TO: Historic Preservation Board
FROM: Department of Doing, Planning Staff

Item Number: 1
DATE: March 7, 2017

SUBJECT: **Petition HB-17-07.** Bonita & Paul Seide, owners. Enclosure of a front corner porch and rear corner porch. Located at 1119 NW 4th Avenue. The building is contributing to the University Heights Historic District- North.

Exhibit 2: Sketches

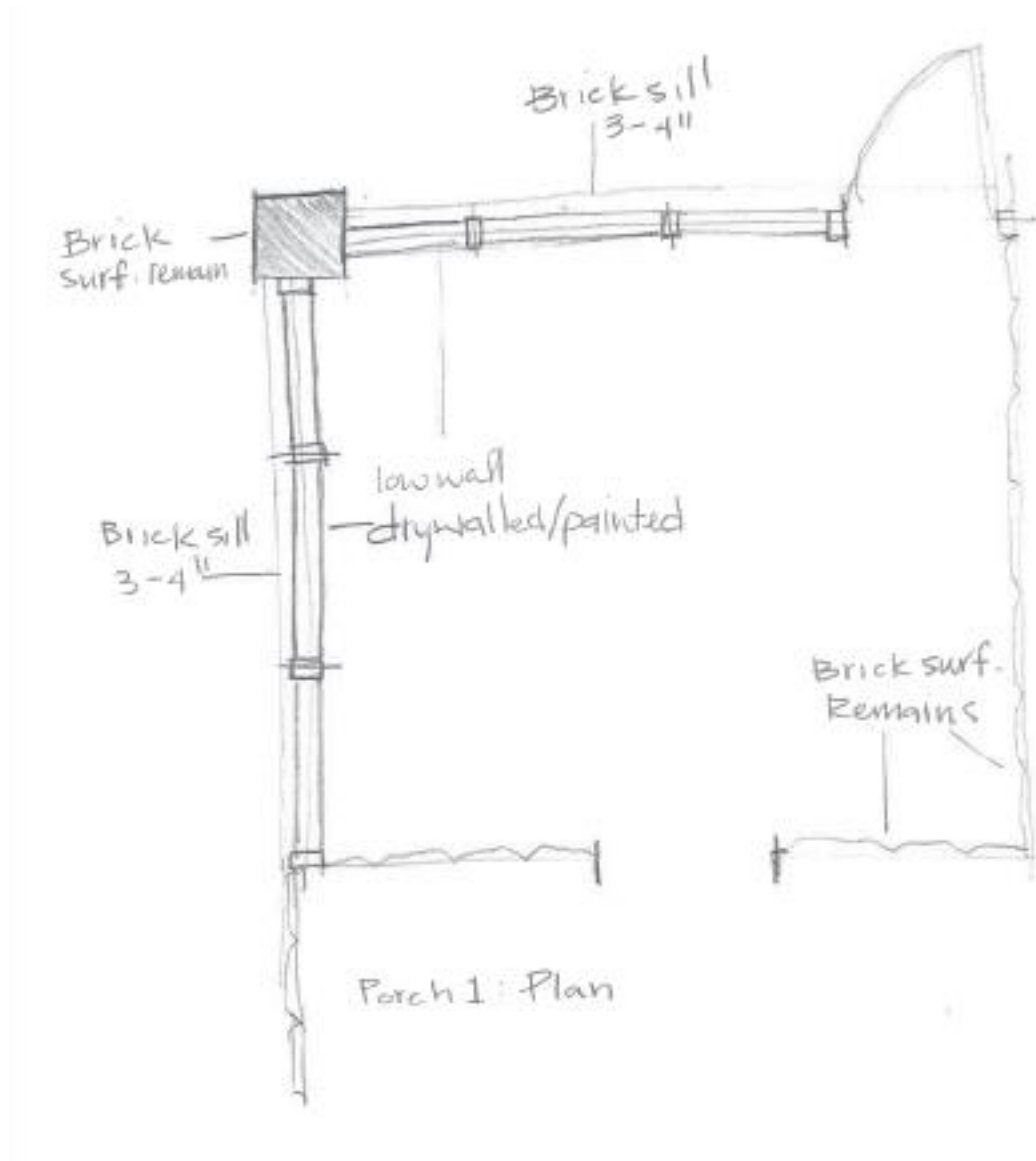
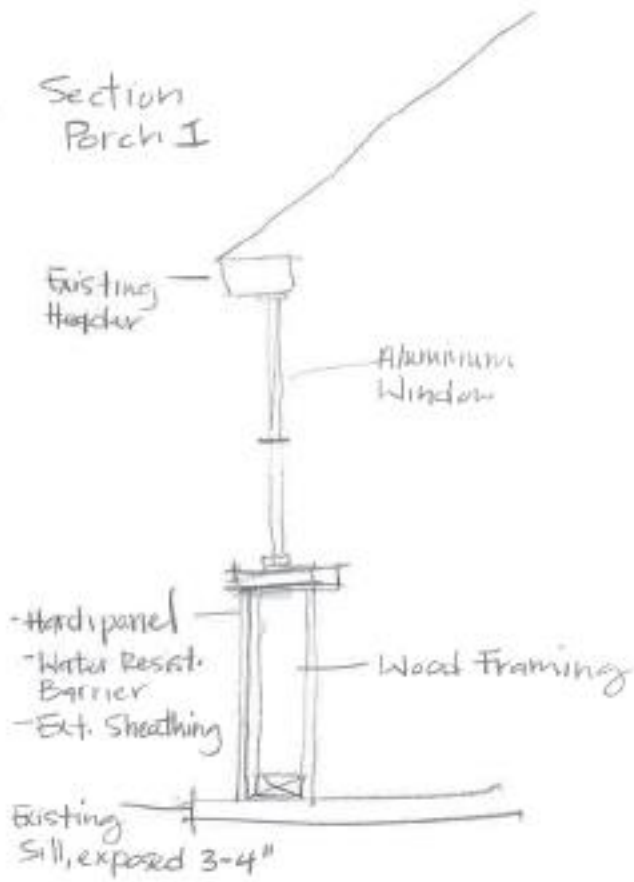
Staff recommends that the new partitions be recessed 3-4 inches behind exterior face of the brick walls (see exhibit 2), so the enclosure reads as a new insertion. Staff also recommends construction of the new partitions on top of the existing porch floor, so that the existing brick sill remains visible. Per the guidelines, *"Place enclosures behind significant detailing so that the detailing is not obscured."*

- Recess new exterior partitions 3-4" from exterior face of the brick walls . Construct new partitions on top of existing porch floor, so that existing brick sill remains visible, and that the existing wood beams are retained.
- Existing exterior brick walls on enclosed porches to remain as-is, without installation of sheetrock or paint.
- Interior grilles on new rear window should attempt to follow proportion and size of panes of existing rear façade windows.
- Construction documents will be reviewed by Historic Preservation Staff once submitted for permitting.

1119 NW 4th Ave: Rear Elevation

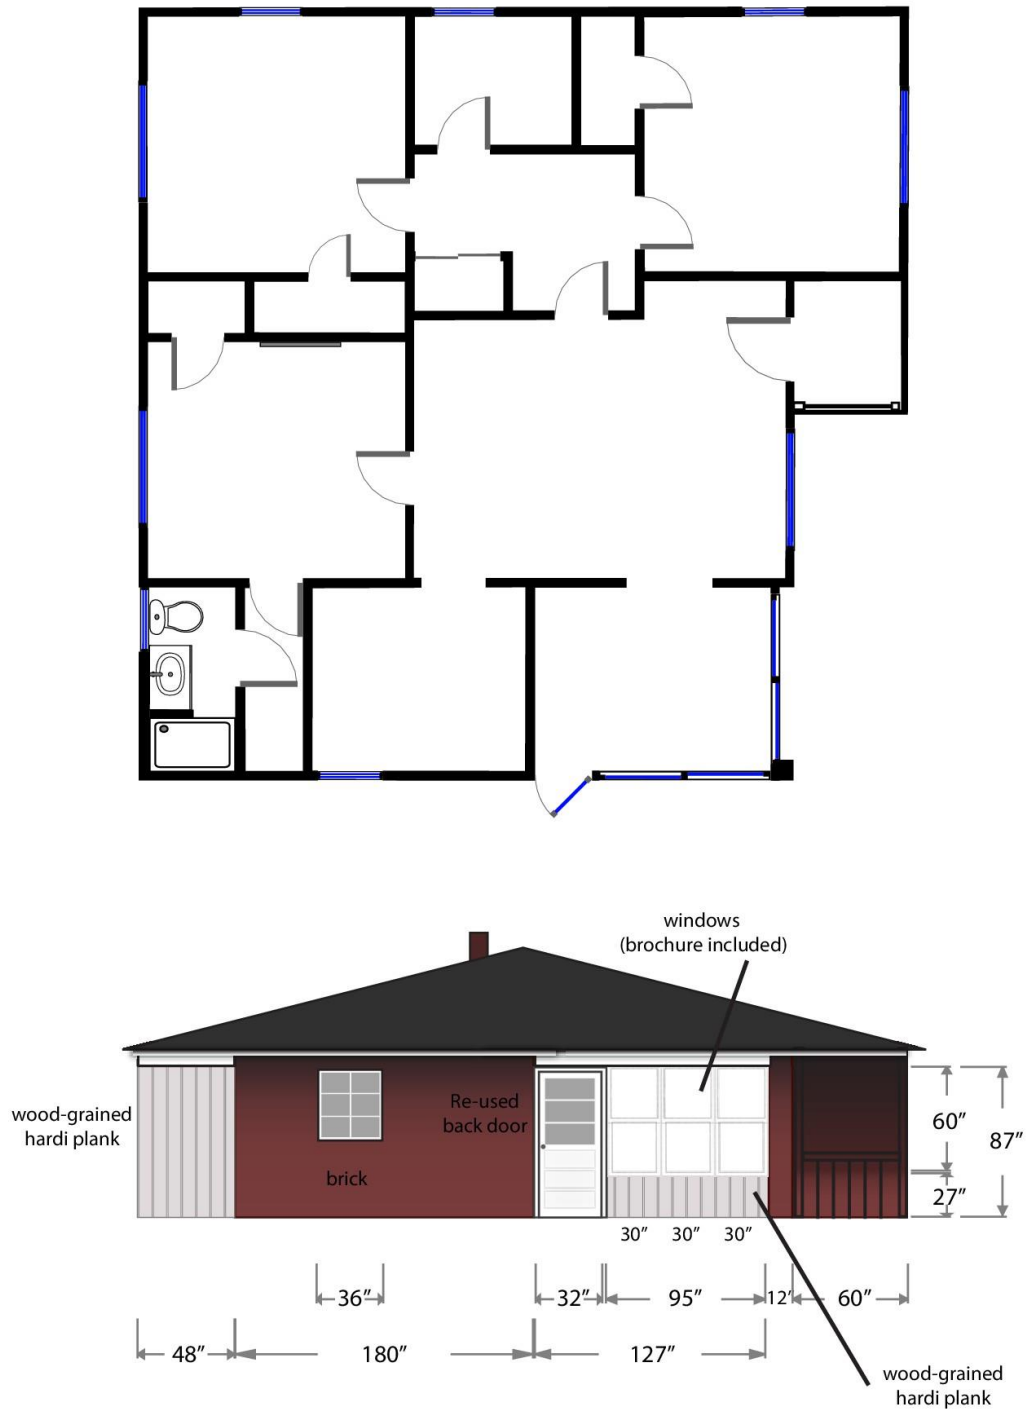
The owner proposes to add a window on the rear wall of the enclosure. This window will be aluminum with interior grilles. Staff finds the interior grilles appropriate as the new window will be on the rear enclosure wall and not visible from the street. Staff recommends that the proportion and size of the new window panes closely follow the existing rear façade windows.
